FINAL PRODUCT/PROCESS CHANGE NOTIFICATION #20498Generic Copy

Issue Date: 03-Jul-2014**TITLE:** Cover Tape Material Change from Heat Seal to Cold Seal for Die Sales Products**PROPOSED FIRST SHIP DATE:** 03-Oct-2014**AFFECTED CHANGE CATEGORY(S):** Packing**FOR ANY QUESTIONS CONCERNING THIS NOTIFICATION:**Contact your local ON Semiconductor Sales Office or <todd.manes@onsemi.com>**SAMPLES:** Contact your local ON Semiconductor Sales Office**ADDITIONAL RELIABILITY DATA:** AvailableContact your local ON Semiconductor Sales Office or <todd.manes@onsemi.com>**NOTIFICATION TYPE:**

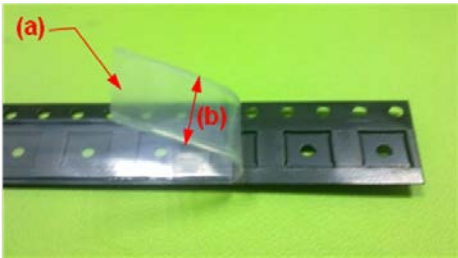
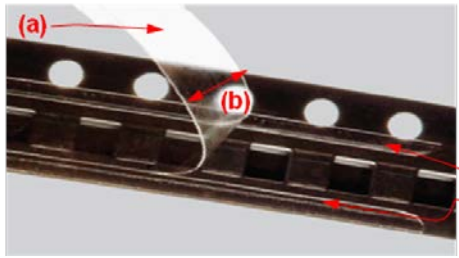
Before	After
Supplier	3M	3M
Part #	2675	UCT 2688A
Type	Heat Seal	Cold Seal
	(a) Cover tape fully peel off from carrier tape (b) Cover tape with heat activated adhesive. 	(a) Tearing effect on center of cover tape (b) Zero adhesive (c) Sealing path (left and right) remain on carrier tape, no glue transfer to customer machine / unit
